Lincoln City Planning Commission
Tuesday, January 4, 2022, 6:00 PM
Zoom, Streamed LIVE on Zoom
801 SW Highway 101 - 3rd Floor, Streamed LIVE on Zoom, Lincoln City, OR 97367

5.1. PUD 2021-02 SUB 2021-01 Lincoln Palisades VI - a 32-lot subdivision/planned unit development

Staff Report
Planning Commission Hearing on November 16, 2021 – continued to
December 7, 2021 – continued to January 4, 2022
Case File PUD 2021-02 SUB 2021-01 Lincoln Palisades Phase VI

3.2

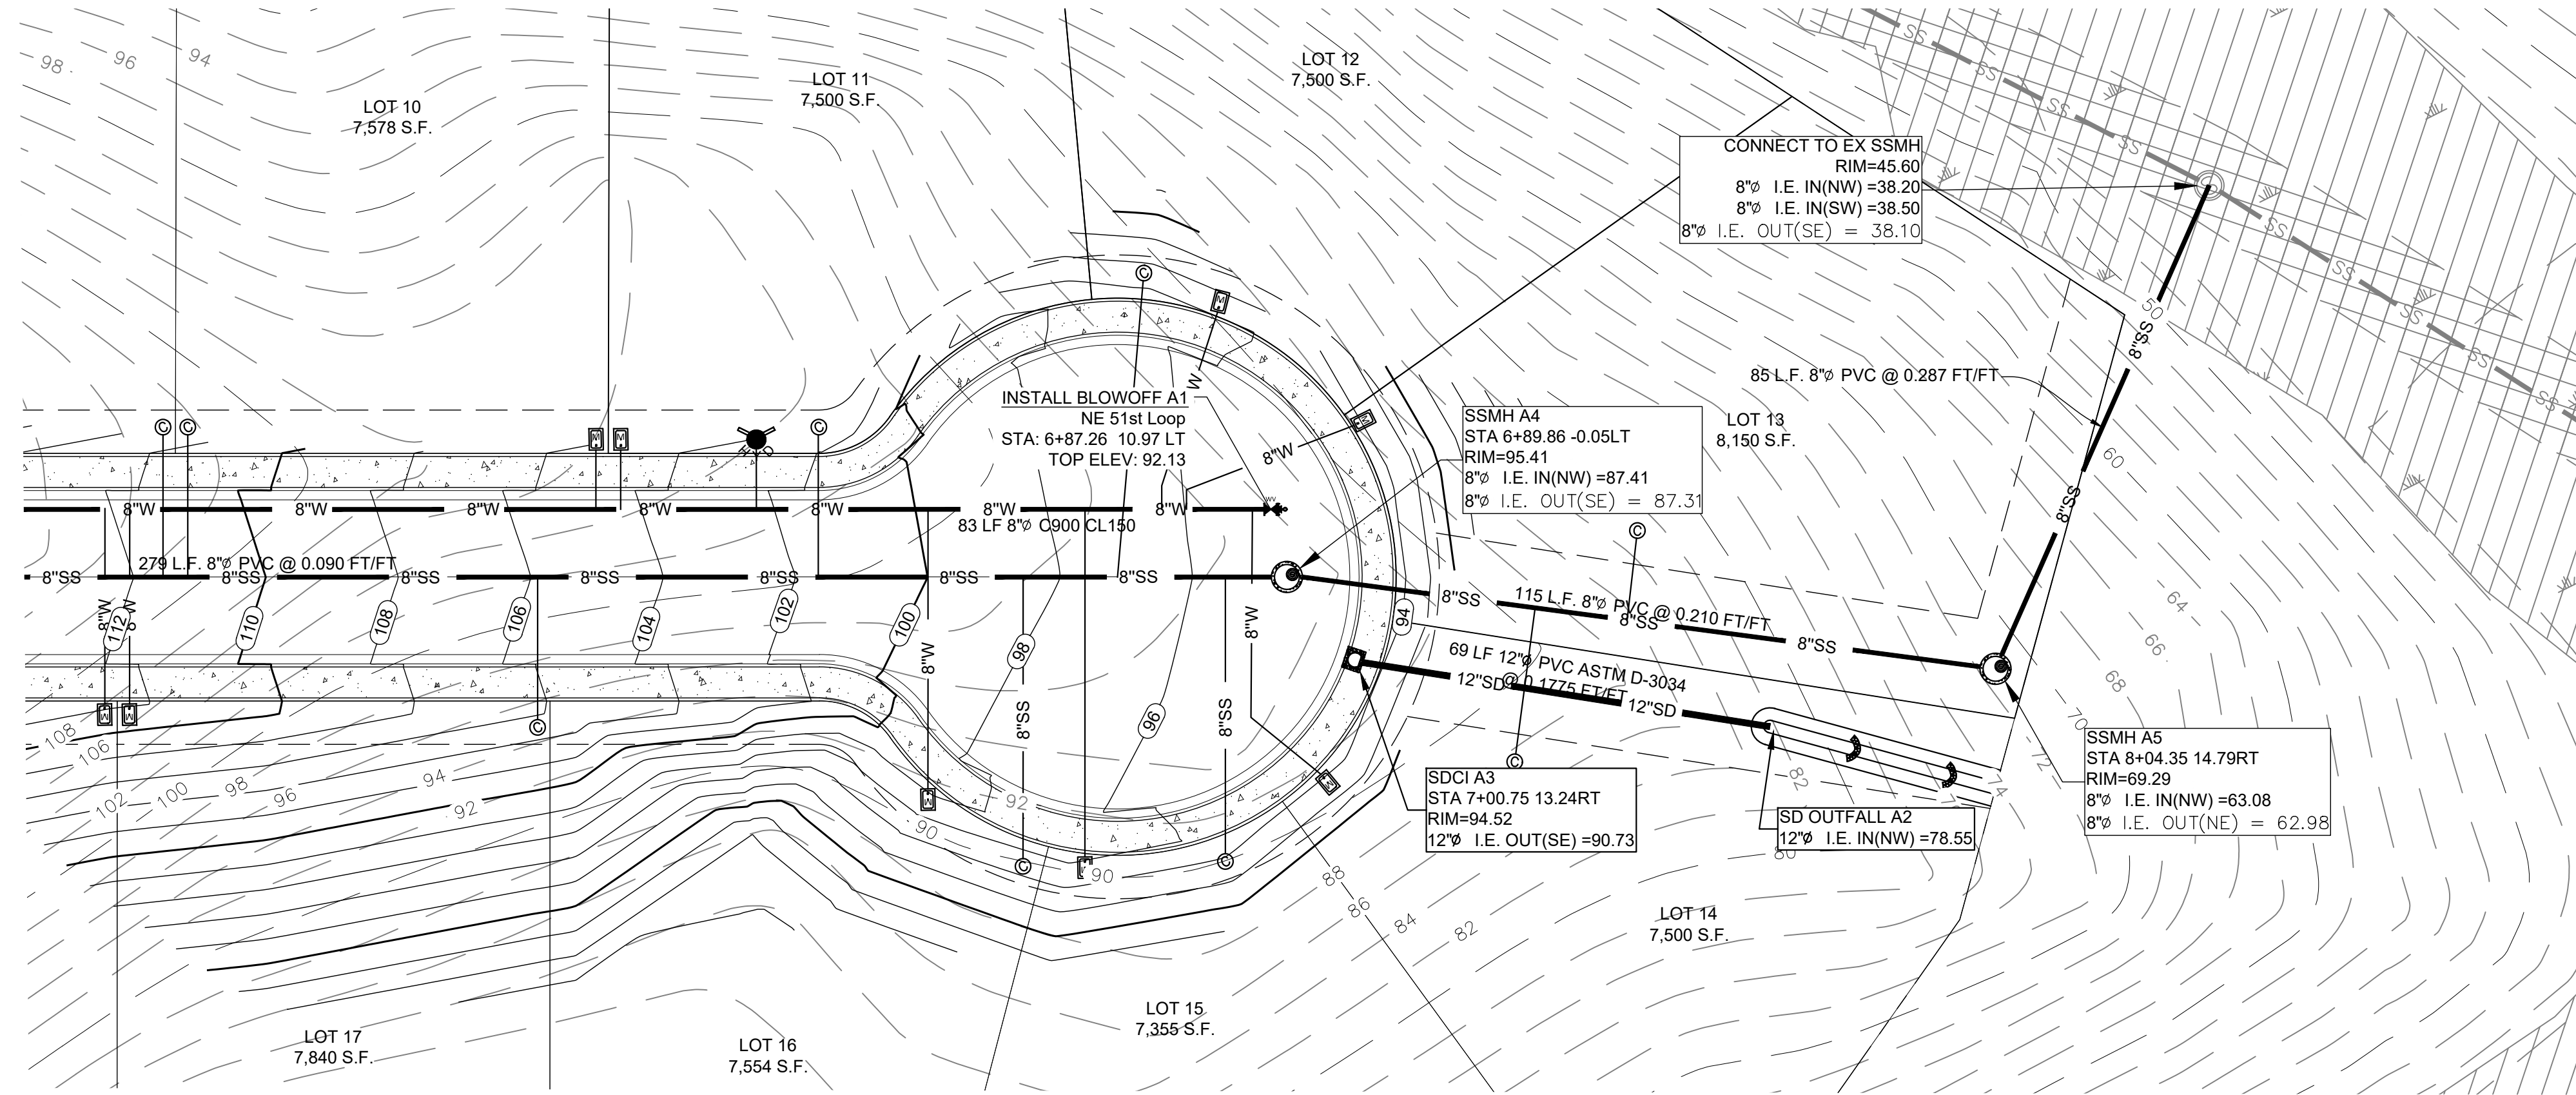
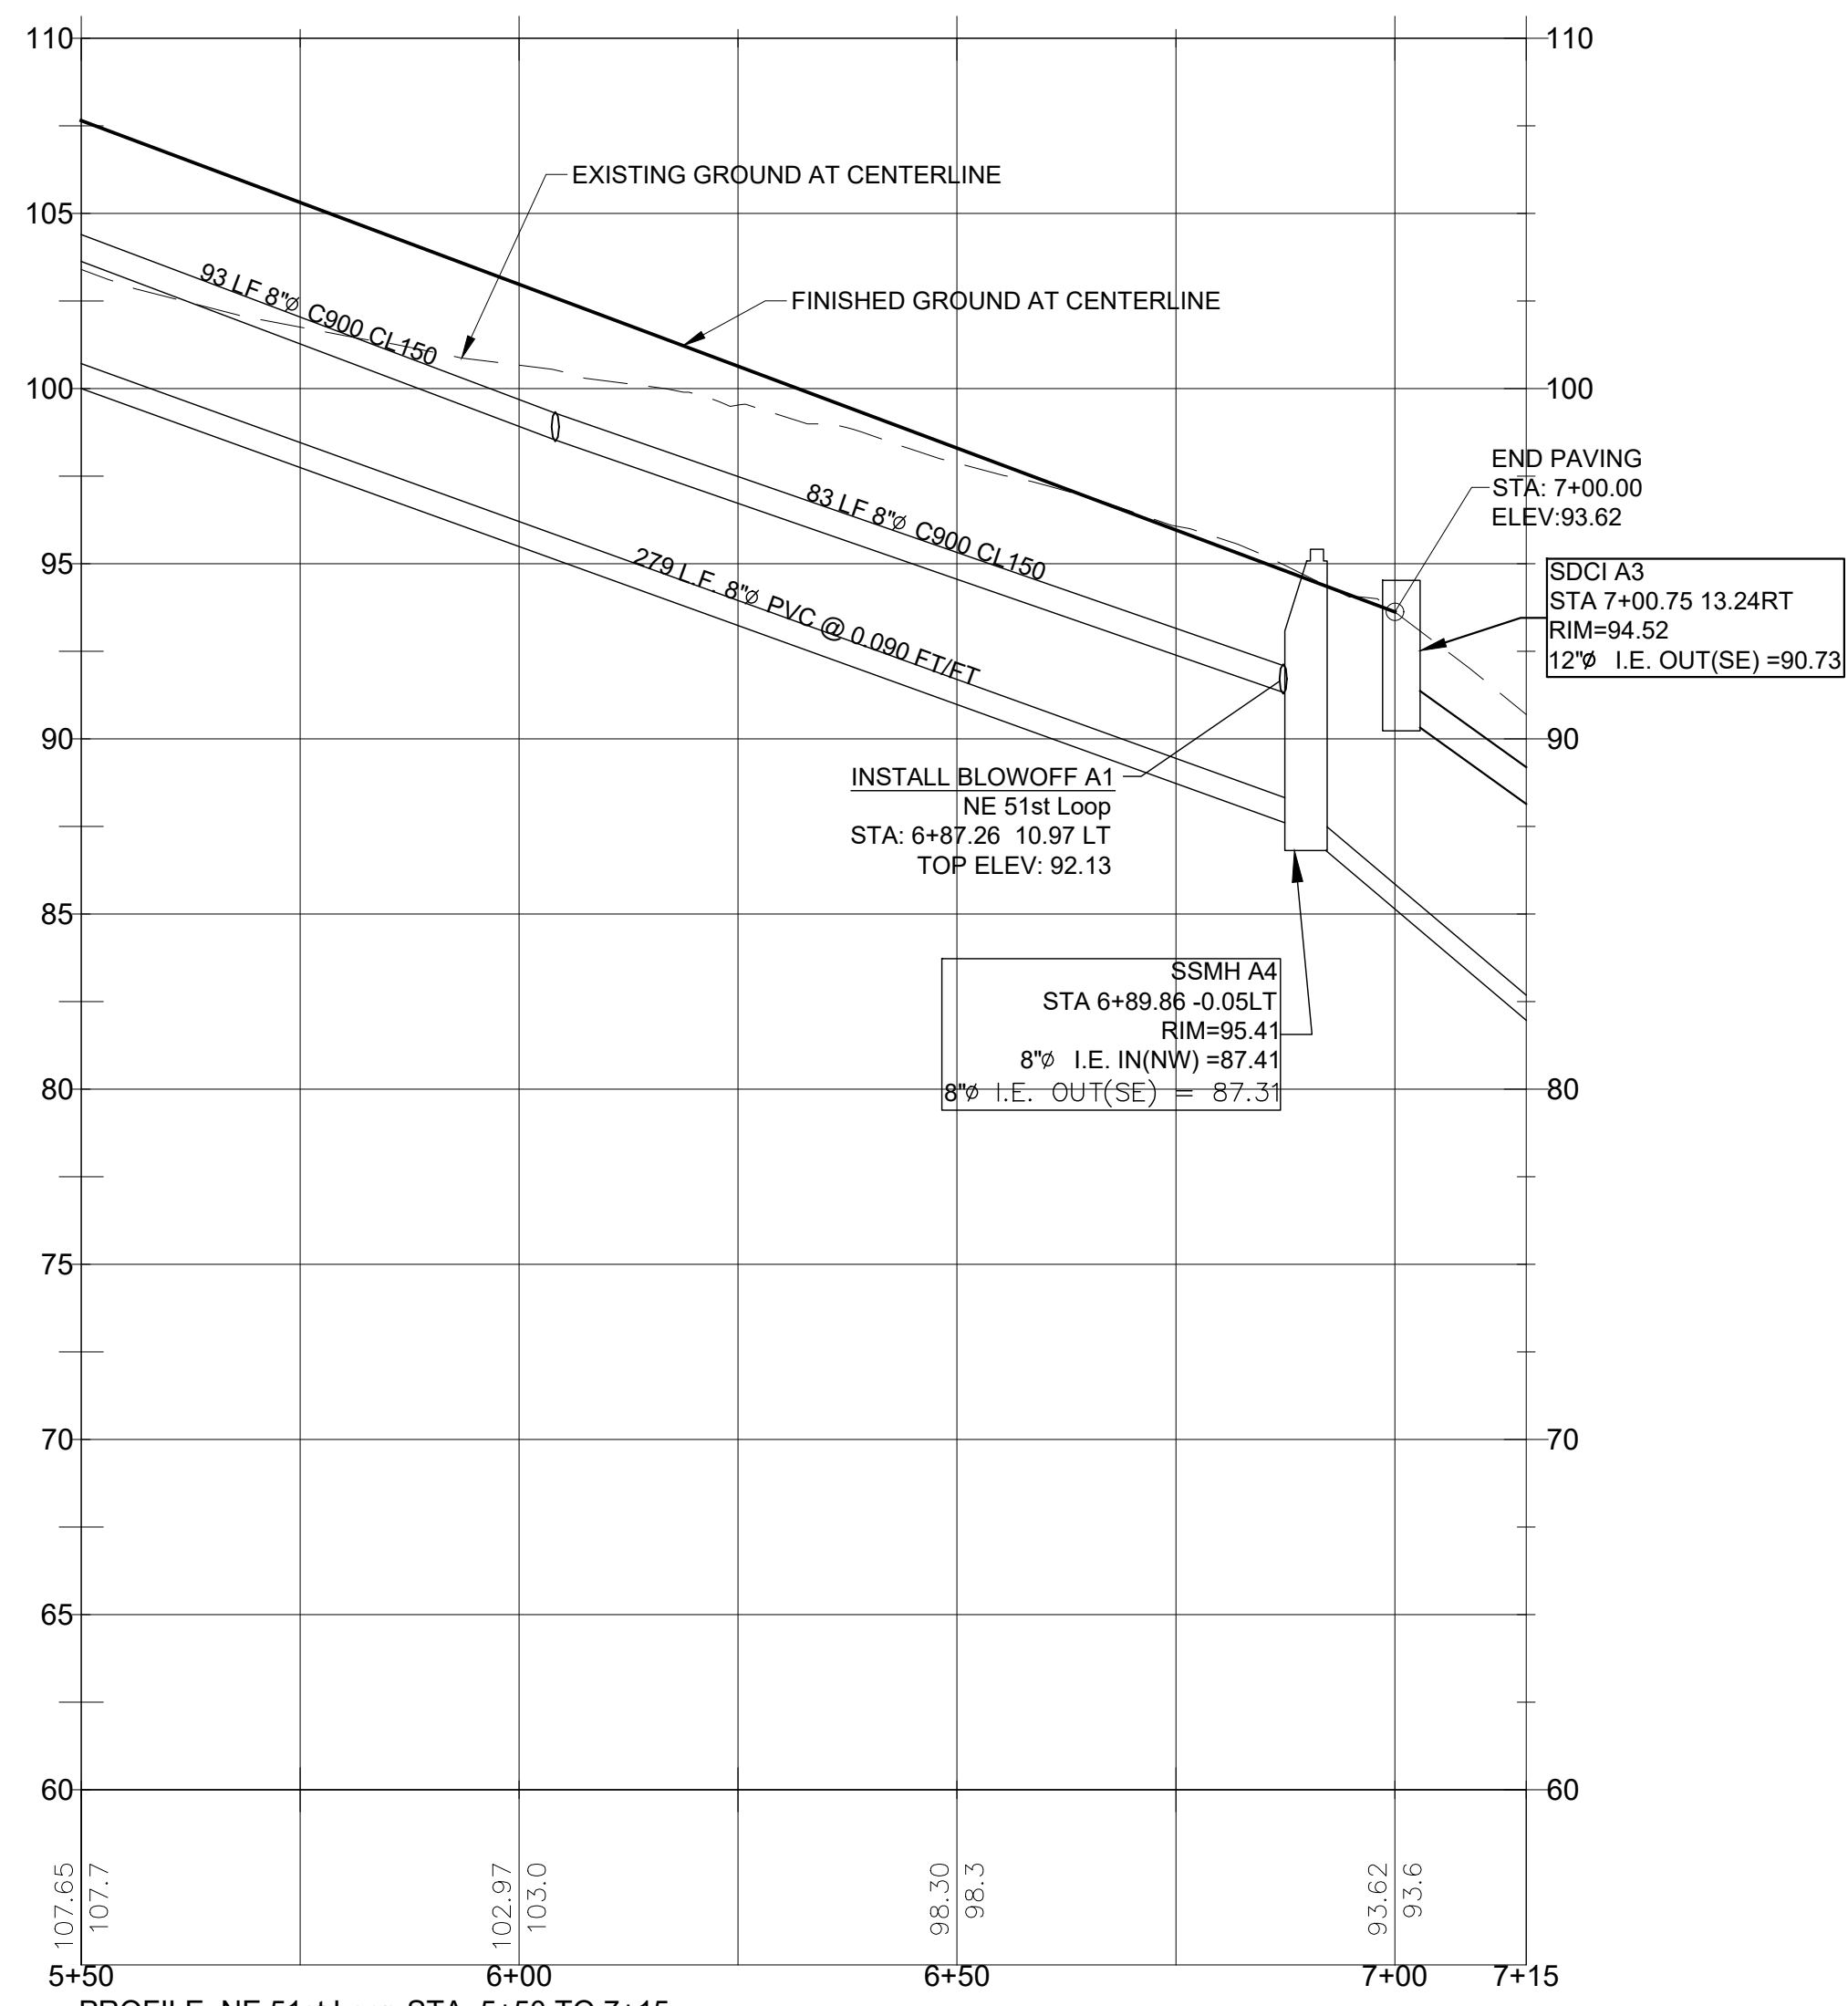
Finding: Sheets 3.1 and 3.2 of the applicant's submitted plan set provide the preliminary landscape and tree plan. Sheet 3.2 lists the six existing trees on the site, but does not provide details on their condition other than noting Tree 1373 splits at the base into two trunks. The legend on Sheet 3.1 has a symbol for "existing tree to be removed" and one for "existing tree to be protected." However, it doesn't appear that either of those symbols are present on the plan itself shown on Sheet 3.1.

The three existing red alder trees are located within the area of the proposed sidewalk, so staff assumes these three red alder trees will be removed. Tree 5158 is in the northeast corner of what is shown as proposed Lot 4 on Sheet 3.1. Without indication of Tree 5158 being non-viable and unhealthy or being able to be protected sufficiently during construction to remain healthy and viable, Tree 5158 needs to be shown as being preserved on the final landscape and tree plan. Tree 1373, along with being noted as having a split base into two trunks, is also located in the middle of proposed Lot 33 as shown on Sheet 3.1. Its location precludes building of a structure on Lot 30, so Tree 1373 needs to be shown as being removed on the final landscape and tree plan. Tree 1374 needs to be protected and preserved since it appears to be a healthy and viable tree. If the applicant provides evidence from the arborist that Tree 1374 is not healthy or viable and/or cannot be sufficiently protected during construction to remain viable, then that information needs to be included the final tree maintenance and protection plan with an indication that Tree 1374 will be removed.

FRONT ELEVATION
SCALE: 1/4" = 1'-0"

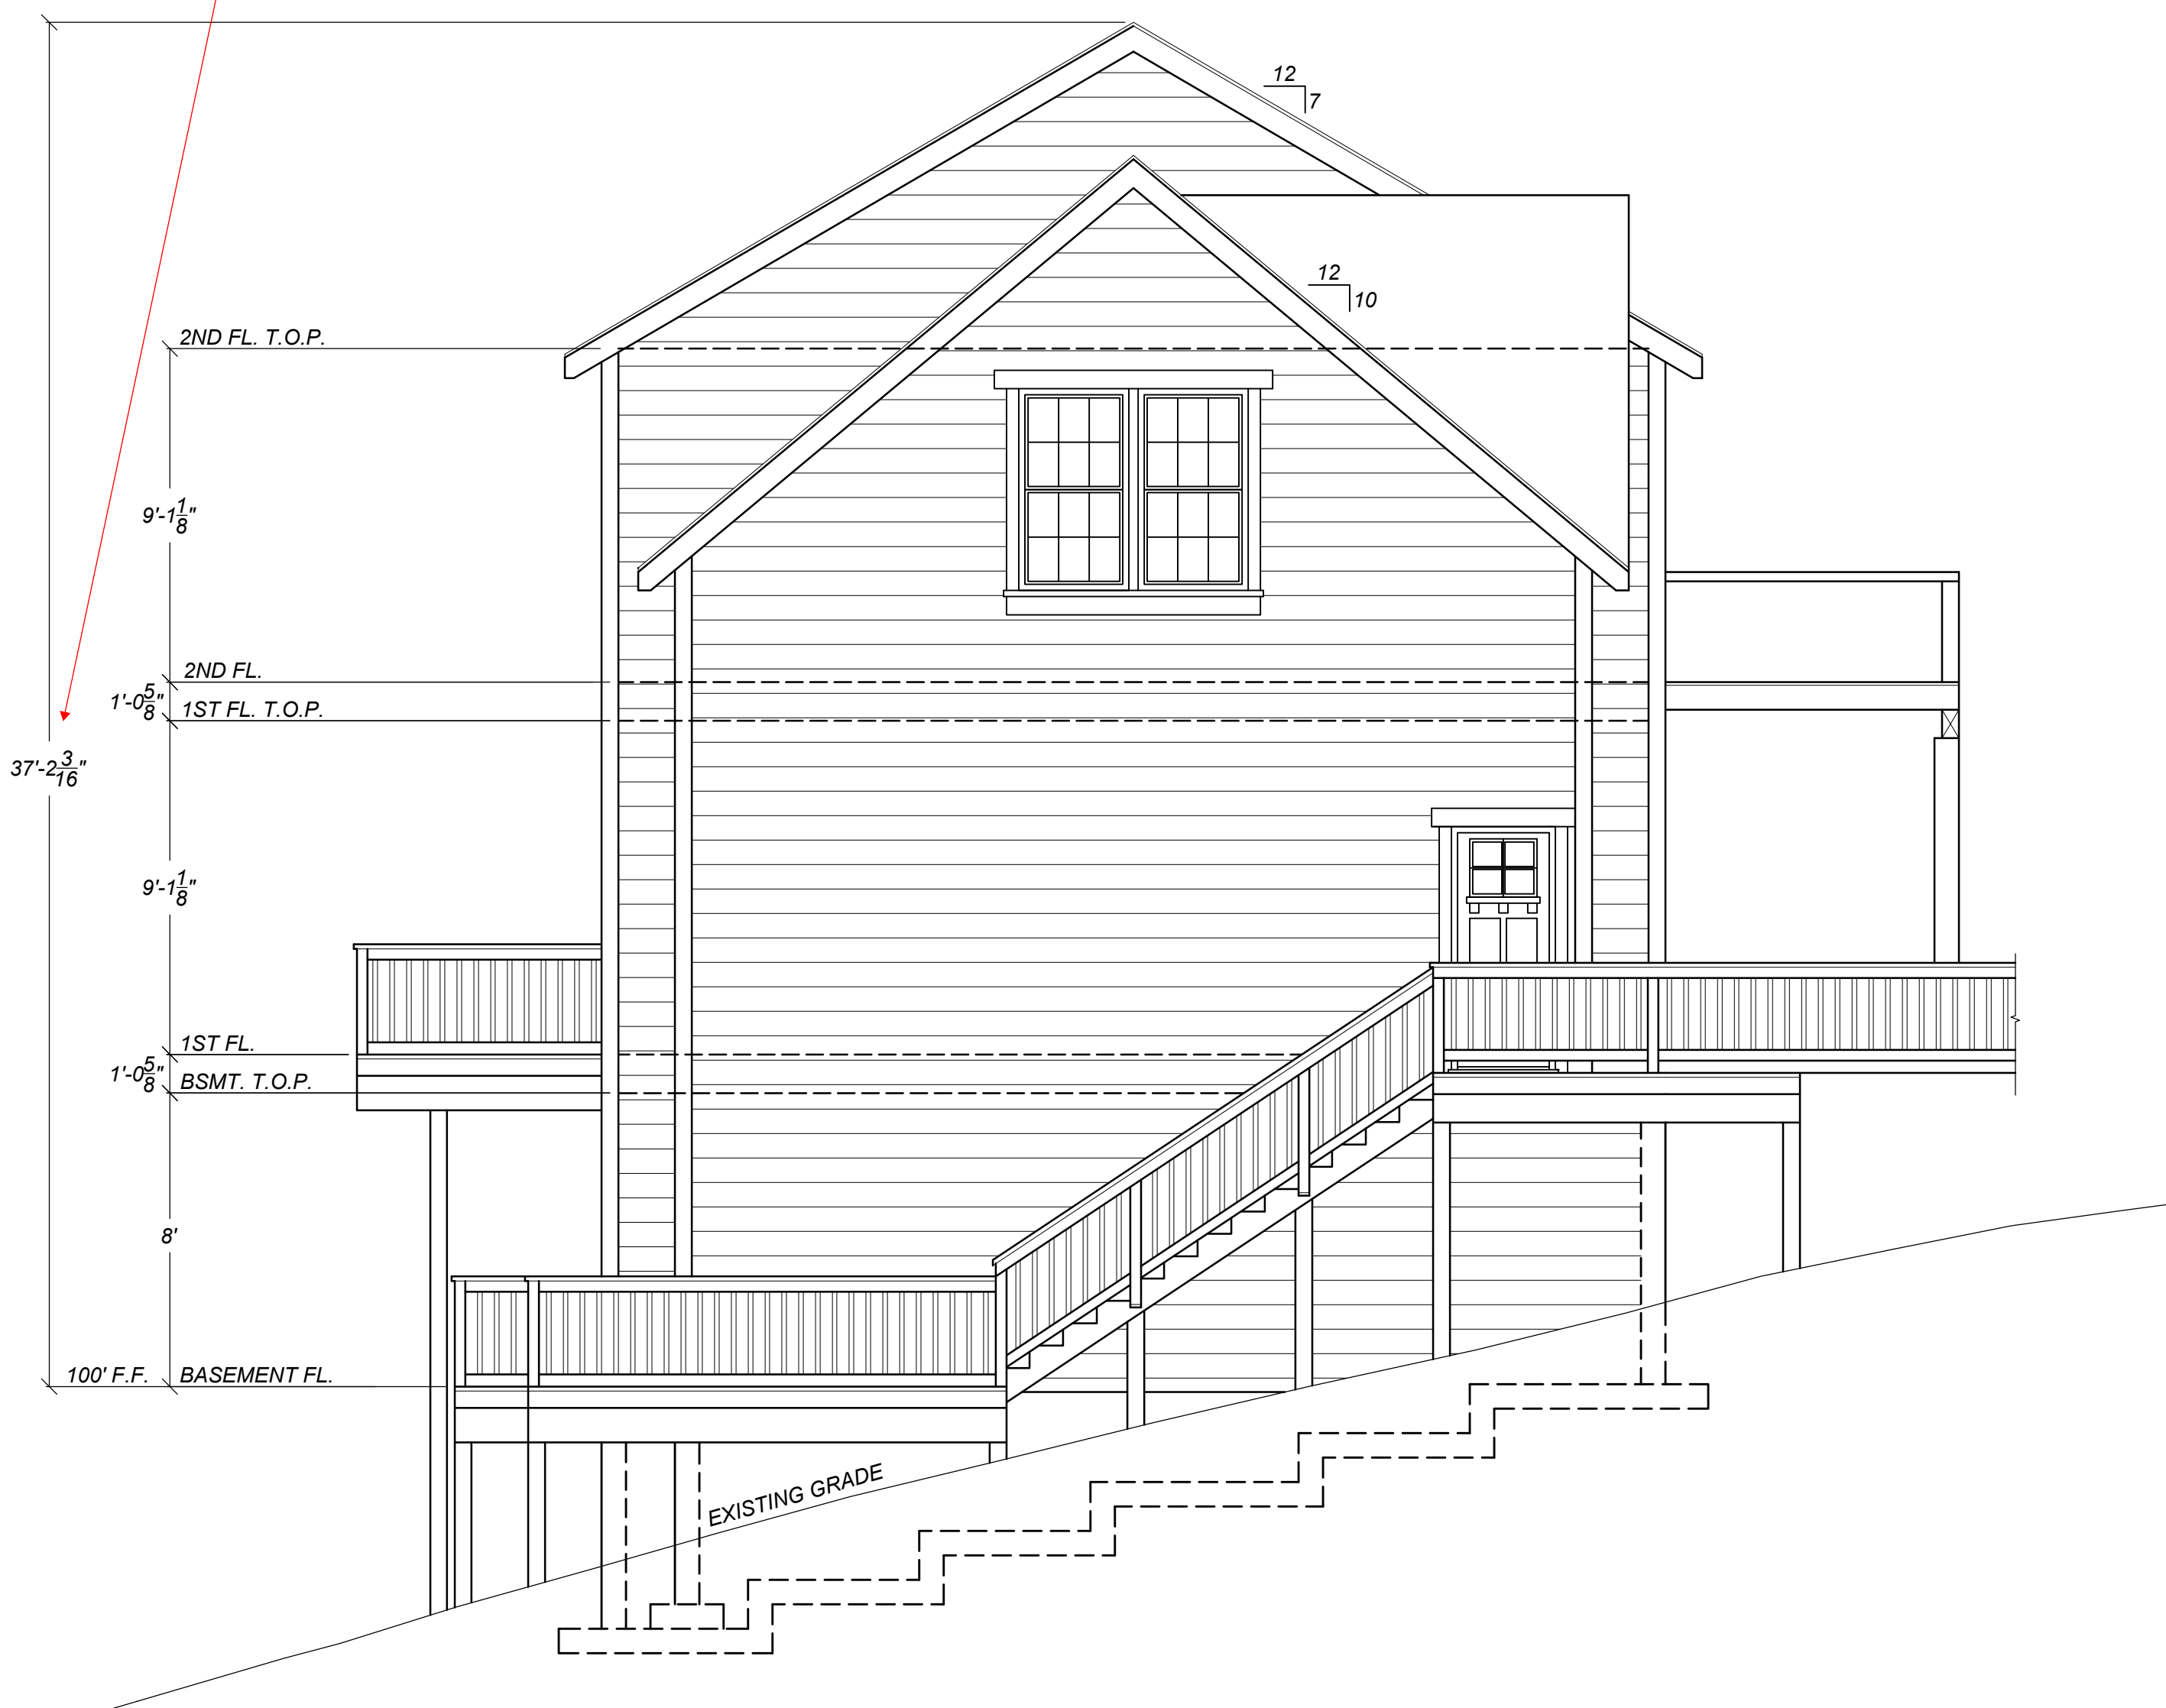
Building Height must be reduced to 35 feet
